MISSOURI RIVER BED DEGRADATION

VALUE ENGINEERING STUDY

VALUE ENGINEERING EVALUATION REPORT

**MISSOURI RIVER
BED DEGRADATION
ALTERNATIVE EVALUATION
AND ANALYSIS
MISSOURI RIVER, MISSOURI
P2# 400367**

Figure 1: Typical side channel chute project.

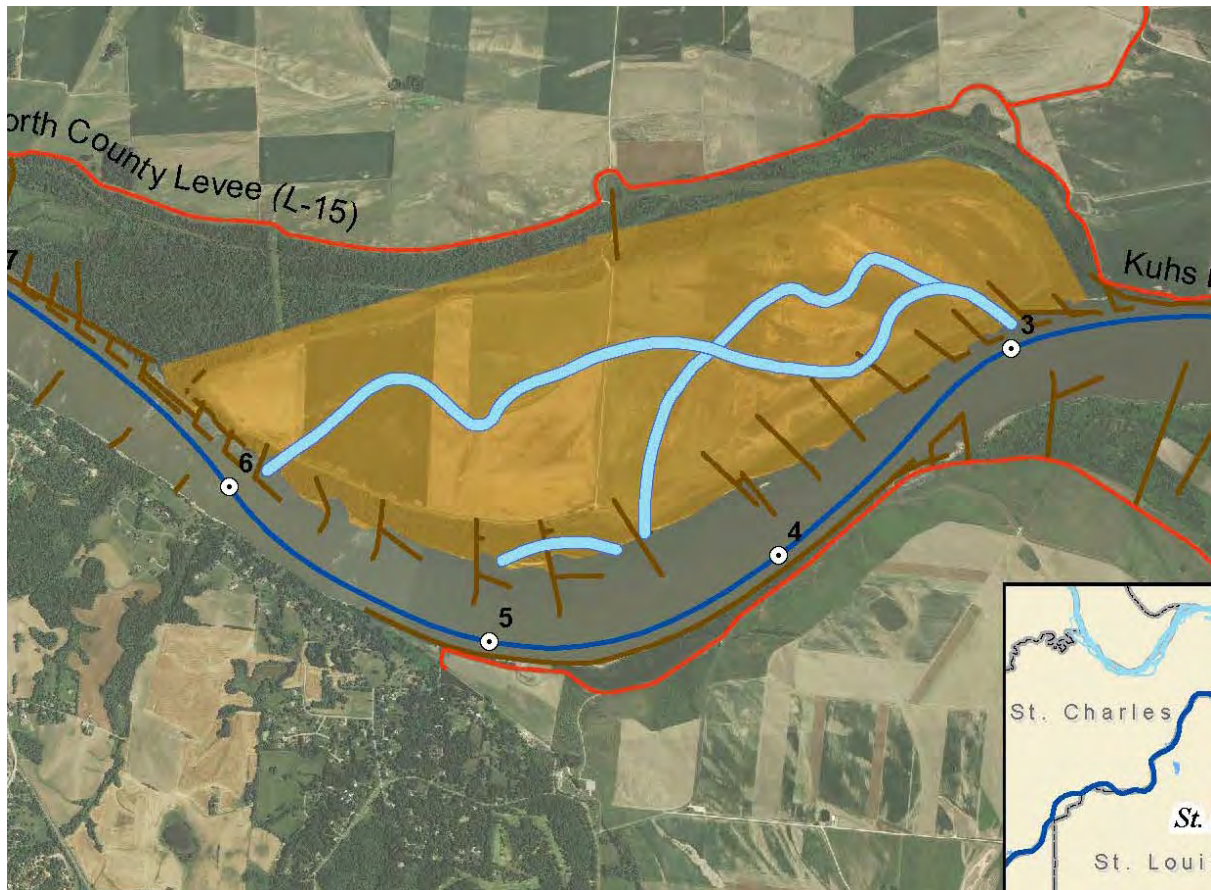
This proposal would benefit more than one Corps mission area, result in win-win scenarios with Endangered Species Act compliance, and could share costs, while designs could be coordinated and shared between the programs.

Figure 2: Levee relocation at Fairfax Industrial Area.

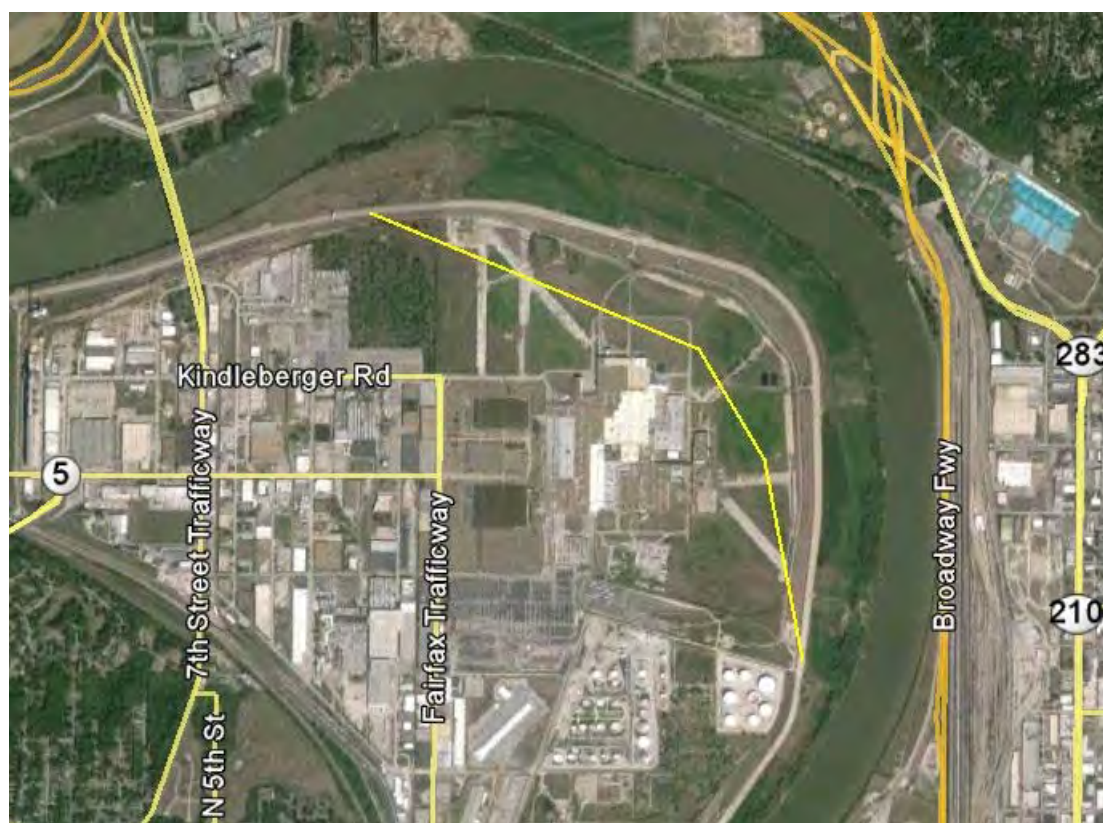
Approximately 2 miles of the levee between river mile 369 and 372 in the Fairfax industrial area could be moved landward. A General Motors assembly plant now occupies some of the former airport site, but a significant floodway could be reestablished on the inside bend at this location. The Kansas City Water Works intake and Highway 169 levee are located on the outside of the bend in this reach of the river and could be benefitted by reduced flow velocities.

Figure 1: Typical top width widening.

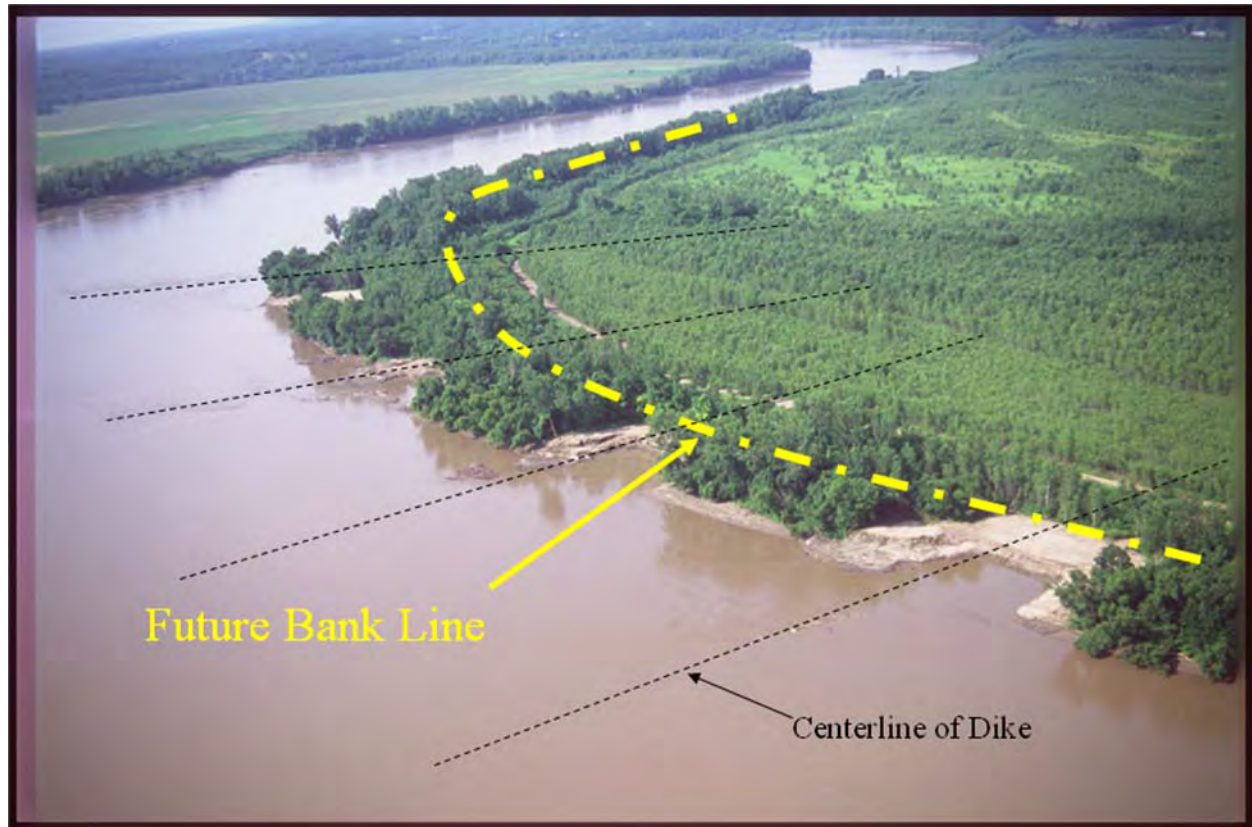
This proposal would benefit more than one Corps mission area, and costs and designs could be coordinated and shared between the programs.
